**Hamburg Township  
Zoning Board of Appeals  
Hamburg Township Board Room  
Wednesday, March 13, 2019  
7:00 P.M.**

# Zoning Board of Appeals Staff Report

**SUBJECT:** ZBA 19-002

**PROJECT:** Variance request to construct a 3,578-square foot dwelling with a 1,139-square foot attached garage. The dwelling will have a 27-foot setback from a regulated wetland and the garage will have a 45-foot setback from a regulated wetland (50-foot setback from a regulated wetland required, Section 9.9.3.B.).

TOPOGRAPHICAL SURVEY AND PLOT PLAN

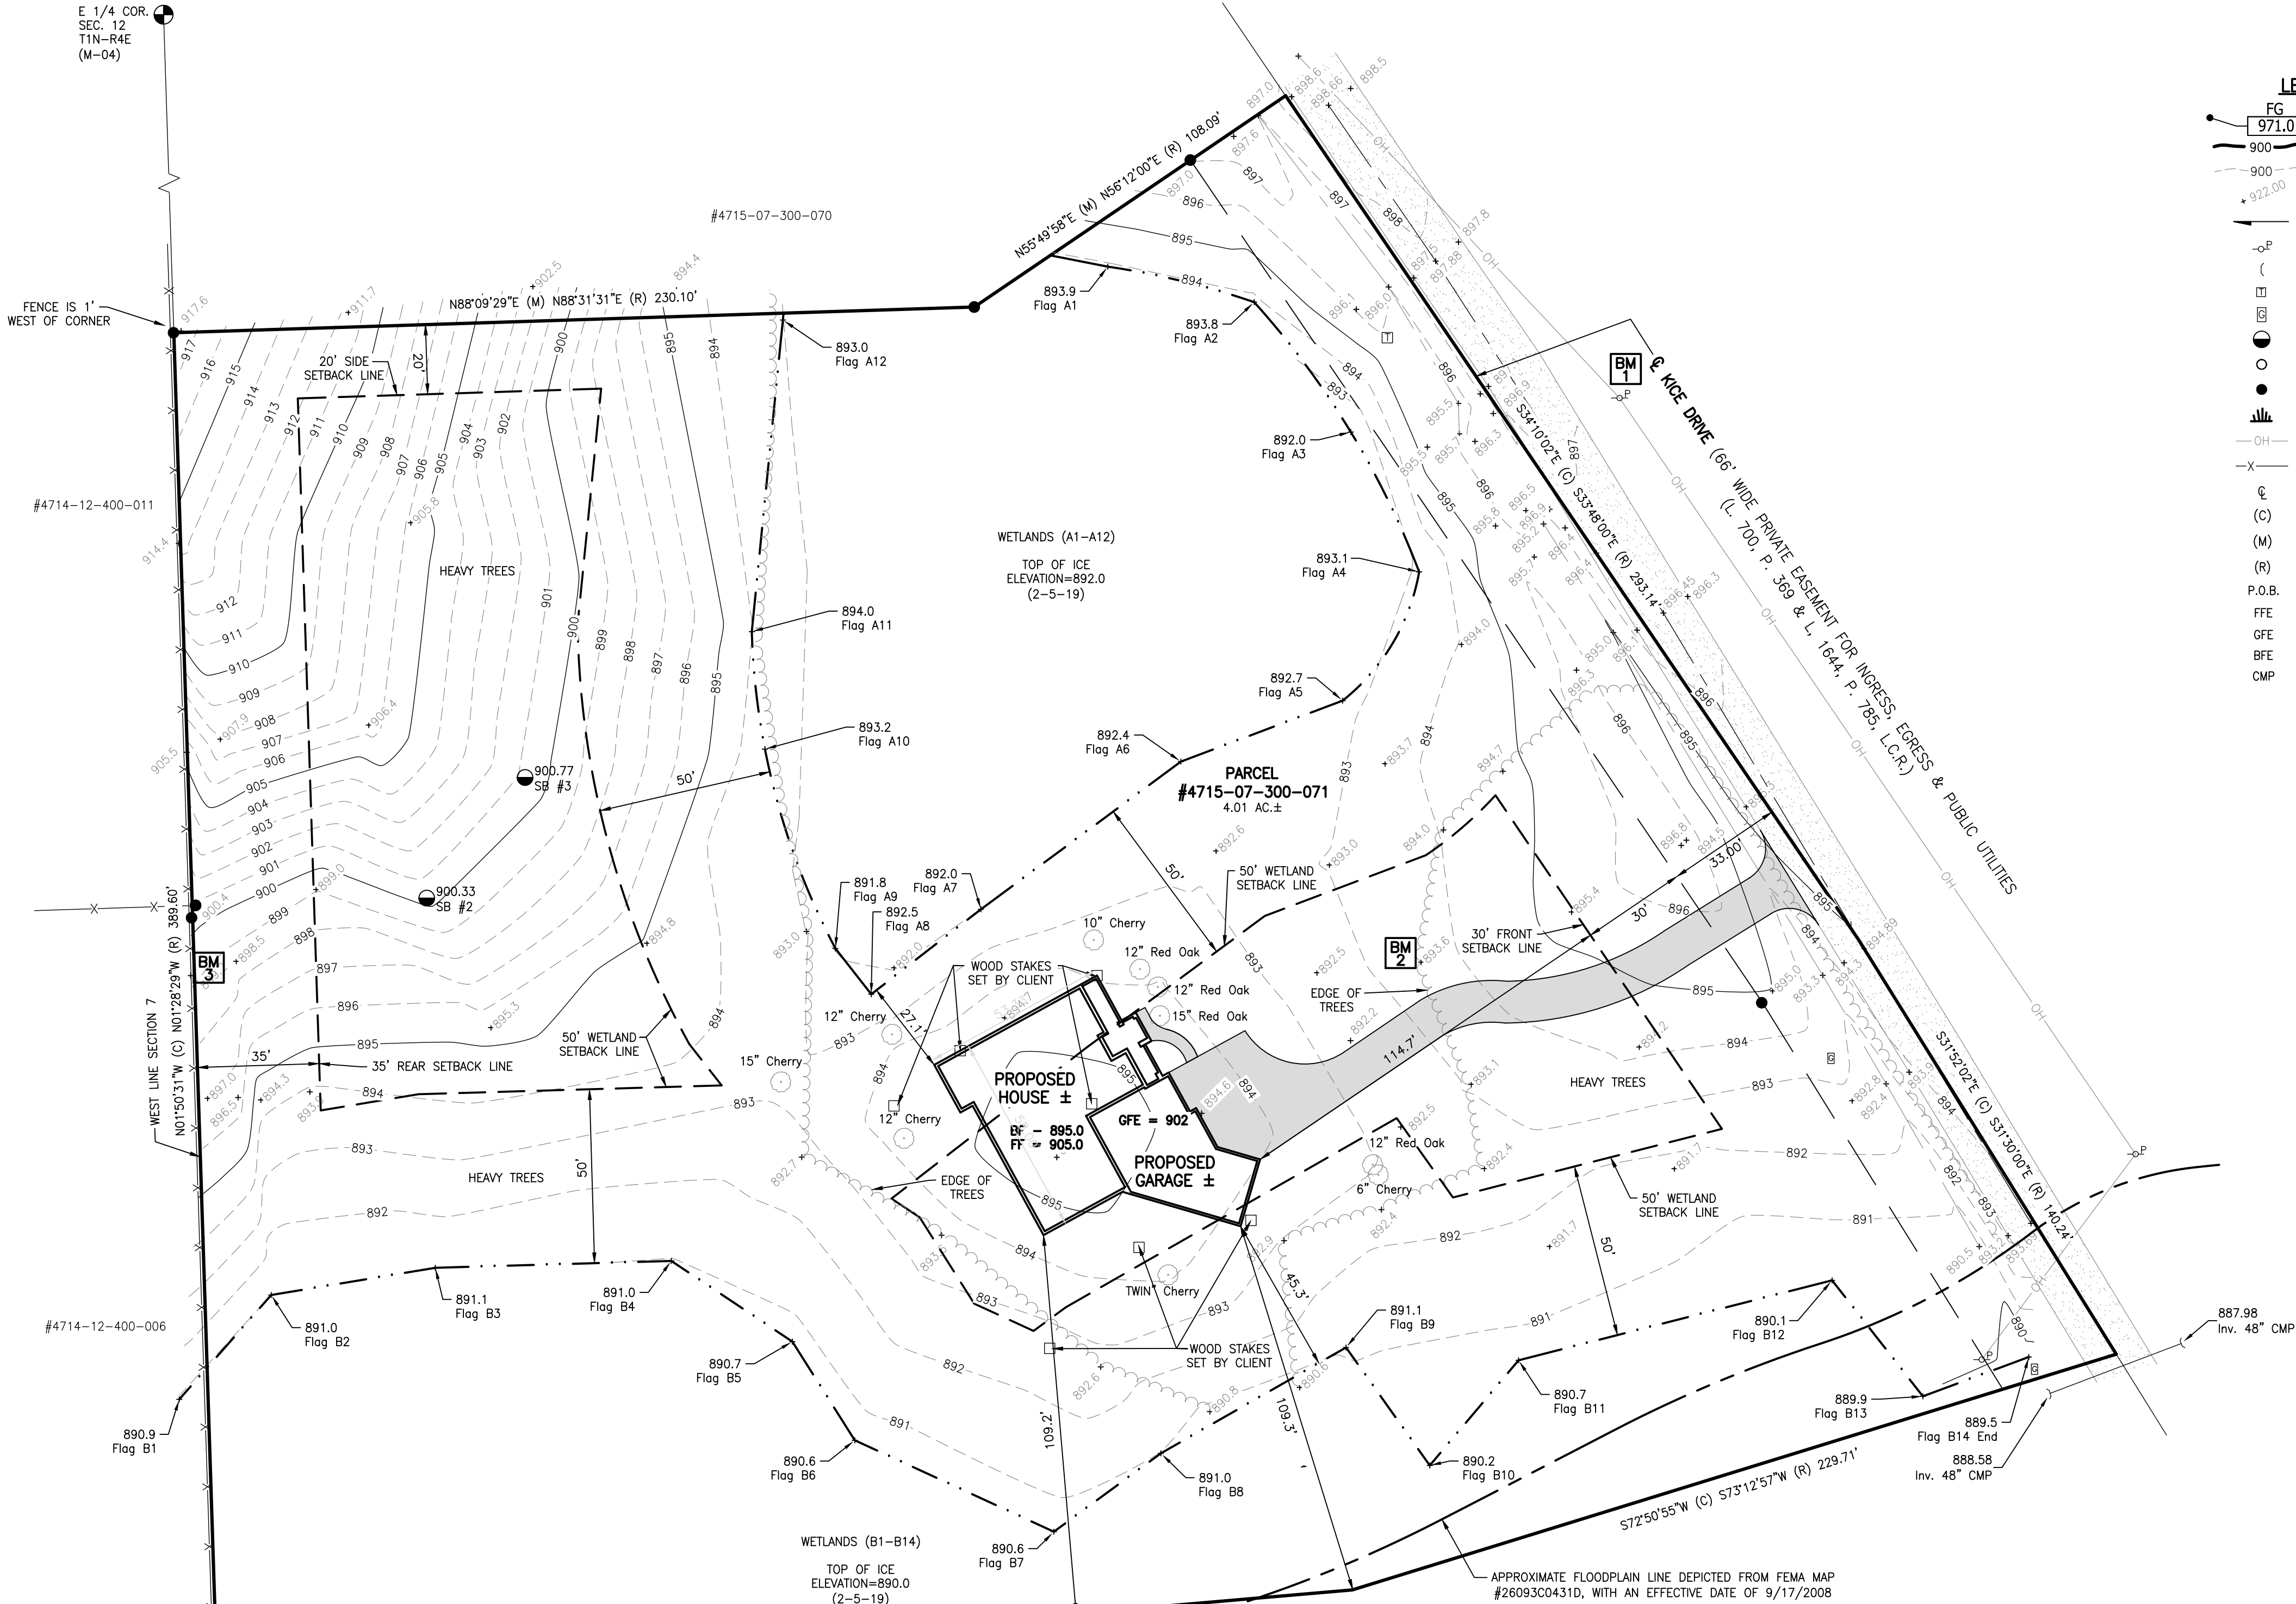
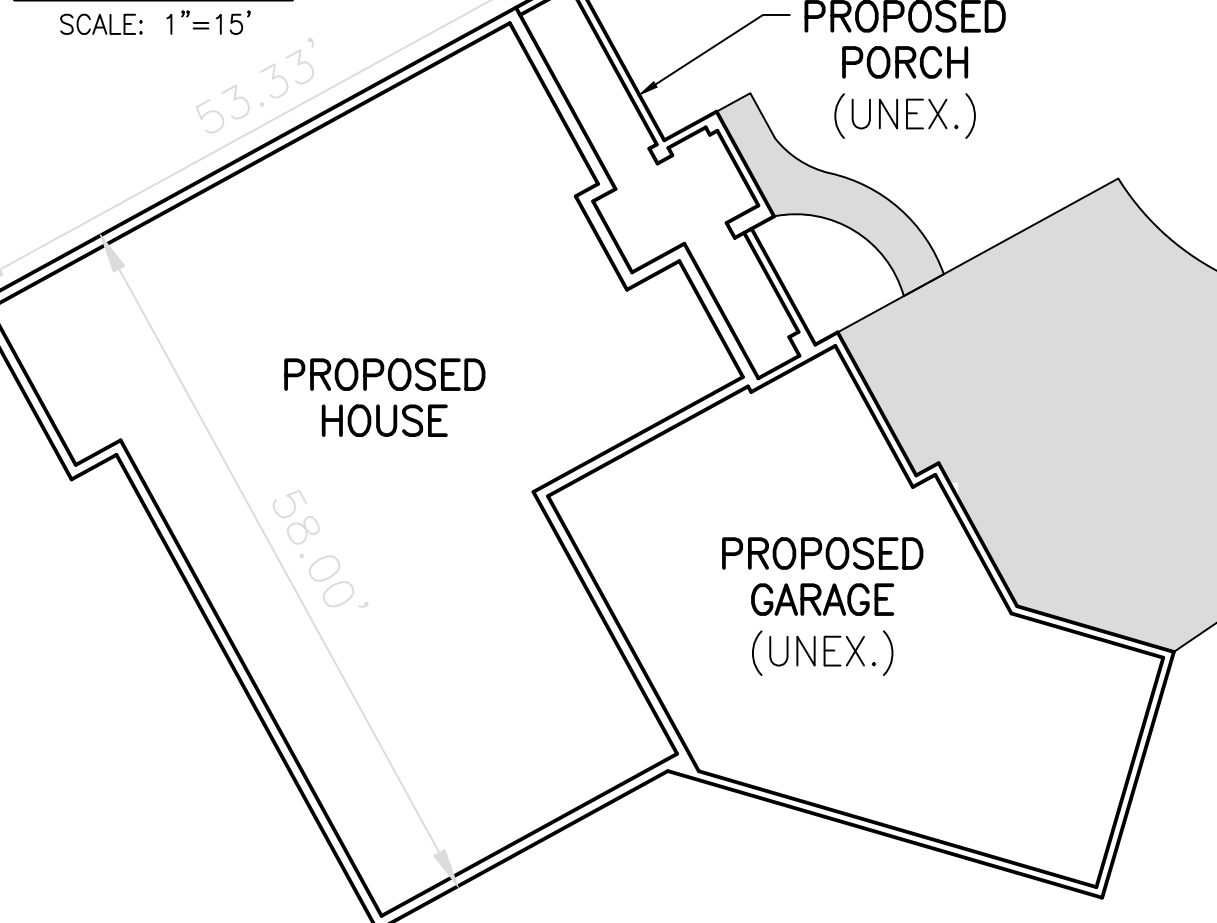
If approved, the variance request would allow for a new 3,578-square foot single-family home with a 1,139-square foot attached garage to have a 27.1-foot setback from the wetlands to the north, and a 45.3-foot setback from the wetlands to the south. The location of the proposed home with an attached garage is going to encroach into the required 50-foot setback from regulated wetlands

22.9 feet to the north and 4.7 feet into the wetland setback to the south.

Dwelling	Proposed	Required
East (front)	114.7 feet	30 feet
North (side)	190 feet	20 feet
North (wetlands)	27.1 feet	50 feet
South (side)	109.2 feet	20 feet
South (wetlands)	45.3 feet	50 feet
West (rear)	205 feet	35 feet
West (wetlands)	75 feet	50 feet

Additionally, staff discovered that elevation plan A7.10 indicates a barricaded sliding door, this describes the possibility of a future elevated deck to be constructed here. The elevated deck is not proposed at this time, but in the future the elevated deck would be proposed where it would not meet the 50-foot required wetland setback. The compliant location for the home, as drawn by staff, also provides ample room to construct a deck that would meet the Zoning Ordinance requirements. In the location proposed by the applicant, any future addition, deck, patio, garage & other improvements to the dwelling as proposed in the requested variance would also require a variance to the 50-foot wetland setback.

1. The homeowner could submit an engineered drainage plan for the property, prepared either by a civil engineer or registered landscape architect, which would ensure runoff from the home and attached garage does not drain into the wetlands.
2. The homeowner could construct a physical barrier along the wetlands to preserve the wetland from further encroachment by lawn equipment or any other trampling of the area.

3. The homeowner could record an open space or wetland easement over the wetland portion of the site to restrict development and interference with the natural vegetation of the area in the future.

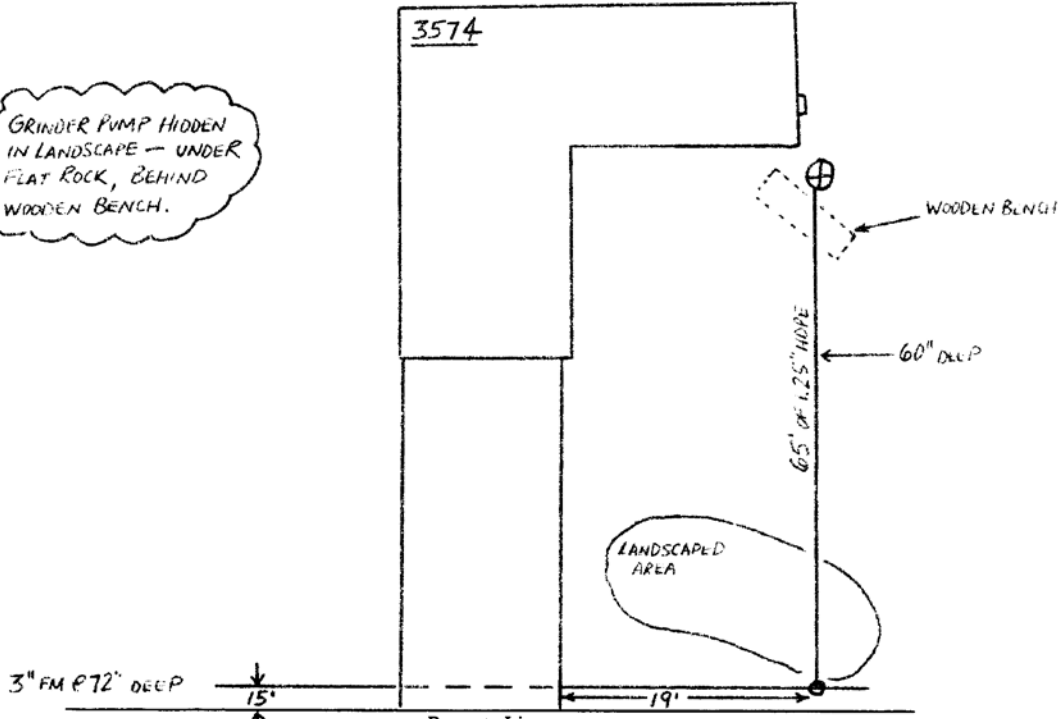
- The property owner is requesting variance to construct a 336 sq. foot enclosed sunroom over and existing patio.
- The grinder pump station and sewer service lateral are located on the northeast side of the property. The sewer service lateral was installed underneath some existing landscaping (see attached sketch).
- Based on the “as-built” drawing for the grinder pump station and sewer service lateral locations, the requested variance to construct the enclosed sunroom will not interfere with the sanitary sewer structures.
- The DPW/Utilities Department has no objections if this variance is granted.
- The property owner or Builder must contact Miss Dig at 1-800-482-7171 at least 3 days prior to any digging or excavation work to confirm the location of the sewer and other utility locations.
